STONE AND WEBSTER MICHIGAN, INC.
P.O. BOX 1963, MIDLAND, MICHIGAN 48640

DATE	2-2-84
J. O. NO.	14509
P. O. NO.	N/A
LTR. NO.	SWOC-84-023
REF.	N/A

STONE AND WEBSTER ENGINEERING CORPORATION
NONCONFORMANCE IDENTIFICATION REPORT

NIR NUMBER 013

NIR 013
ATTACHMENT 2
SHEET 2 of 2

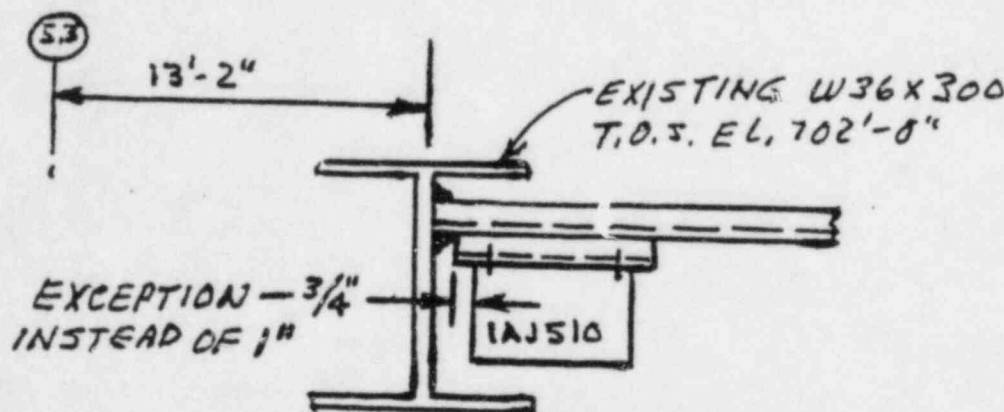
SPACE LIMITATIONS

BOX 1AJS10 REQUIRES A SUPPORT

TYPE 22 JUNCTION BOX SUPPORT WITH
EXCEPTION AS SHOWNEL. LOOKING NORTH, 2 FEET
NORTH OF K LINE

DOCUMENT REVISION
NOT REQUIREDSigned L. J. Lee Date 8-21-79

NO DRAWING INCORPORATION REQUIRED
